### NOTICE OF APPLICABILITY

**WATER QUALITY ORDER 2015-0121-DWQ  
GENERAL WASTE DISCHARGE REQUIREMENTS FOR COMPOSTING OPERATIONS  
K&S SPREADING AND HAULING, INC.  
GLENN COUNTY**

**SUBJECT: APPLICABILITY OF COVERAGE UNDER STATE WATER RESOURCES CONTROL BOARD WATER QUALITY ORDER 2015-0121-DWQ, K&S SPREADING AND HAULING, INC., 7165 COUNTY ROAD 24, ORLAND, GLENN COUNTY**

# Attachment A

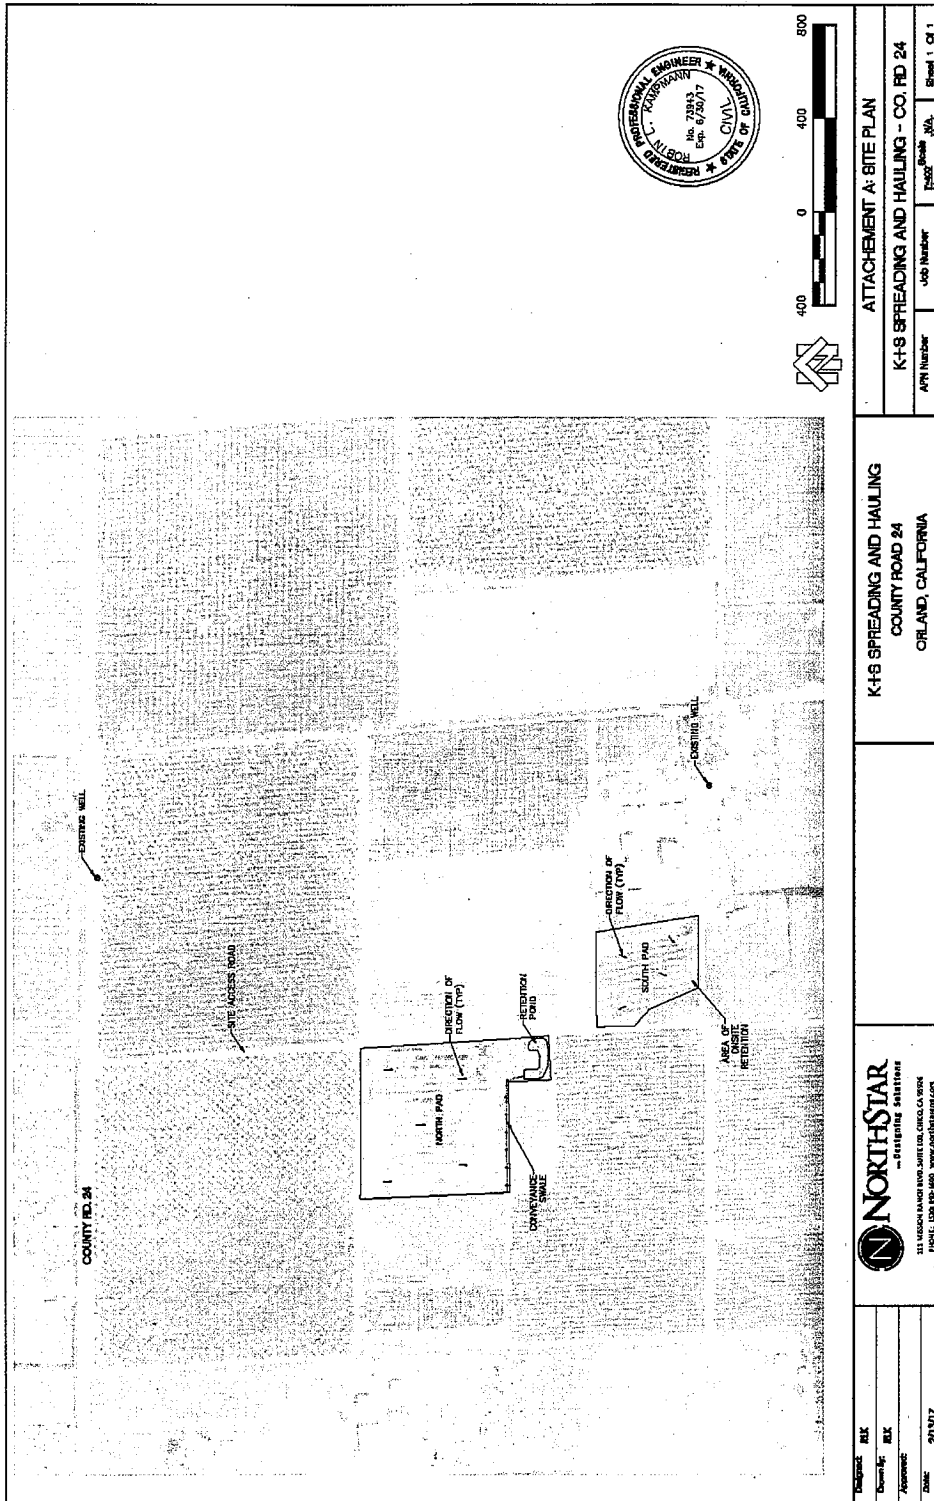
The nearest water supply well is a domestic well that serves an existing residence located 650 feet to the southeast of the Facility, which is greater than the General Order setback requirement of 100 feet. In addition to the domestic well there is an existing agriculture irrigation well located approximately 1,325 feet northeast of the Facility. Attachment A shows the location of the existing water supply wells in the area.

According to the NOI, the Facility only allows manure and has a maximum capacity of 20,000 cubic yards. No additives or amendments are used. Compostable materials will be on-site year round (January through December). The current site is composed of two compost processing/storage pads, the north pad and the south pad, a storm water retention pond and an access road. There are no waste handling areas, buildings or equipment cleaning facilities at this location. Attachment A provides a site plan.

The Technical Report reveals that composting operations on native surfaces (Cortina and Tehama loams) may not be compliance with the requirements of the General Order. Per the General Order working surfaces must have a hydraulic conductivity of  $1.0 \times 10^{-5}$  cm/s. The hydraulic conductivity in cm/s for the Tehama loam ranges from  $1.4 \times 10^{-4}$  to  $4.0 \times 10^{-4}$  cm/s and the Cortina loam ranges from  $1.4 \times 10^{-3}$  to  $4.2 \times 10^{-3}$  cm/s. Although the working surface has been compacted, the average ground surface material percolation rate is 0.03 MPI. For composting operations with percolation rates less than 1 MPI, the required minimum depth to groundwater is 50 feet. It is unclear if the working surface meets the hydraulic conductivity requirements or if the depth to groundwater at the Facility is at least 50 feet bgs. The nearest water supply well is a domestic well that serves an existing residence located 650 feet southeast of the Facility, which is greater than the General Order setback requirement of 100 feet. The nearest surface water (Tehama Colusa Canal) is located approximately 2.25 miles northwest of the Facility which is greater than the setback requirements of the General Order.

- By **30 September 2017**, the Discharger must provide supplemental information (i.e., percolation test results, site-specific hydraulic conductivity data, and depth to groundwater at the Facility) that demonstrates that the working surface is in compliance with the General Order. If the Facility does not meet the criteria for working surface, the Discharger must provide recommendations for site improvements or the Facility will be considered a Tier II composting operation.
